**NIJ Standard 0101.07, *Ballistic Resistance of Body Armor*
Addendum 1**

October 31, 2024

This addendum includes revisions to NIJ Standard 0101.07, *Ballistic Resistance of Body Armor*. Users of the NIJ Standard should incorporate the revisions in this addendum as a part of the NIJ Standard.

Figure 8. NIJ RF1, NIJ RF2, and NIJ RF3: Example of Shot Placement for 3 Shots per Test Item on a Multi-Curve Plate

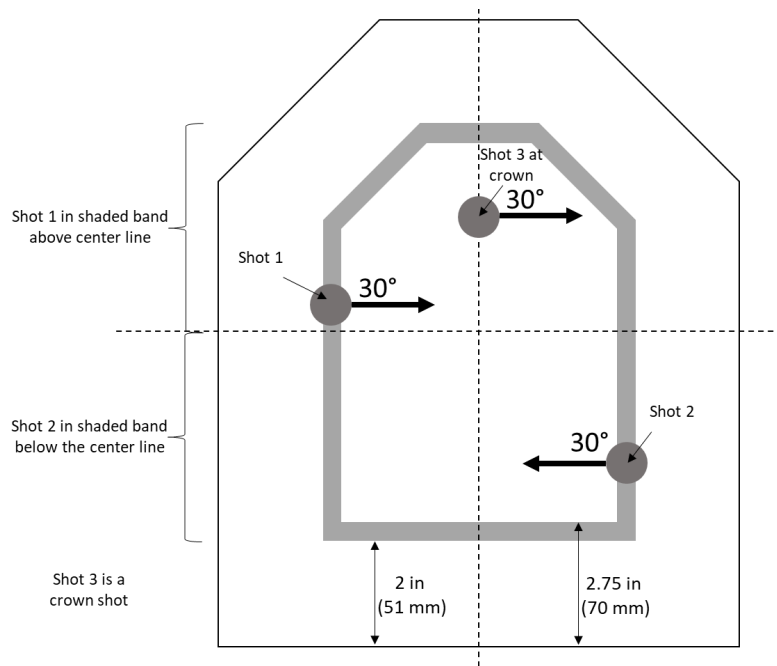
Revision: Figure 8 is modified to show the shot on the left in the band pointing 30 degrees inward toward the center rather than 30 degrees outward toward the edge.

12.2.2.4. For a 3-shot plate with 30-degree shots, refer to Figure 8. The following requirements apply:

- (1) The crown shot and the next closest shot shall be angled **parallel** to each other.
- (2) The **shots in the shaded band** shall be angled toward the centerline.
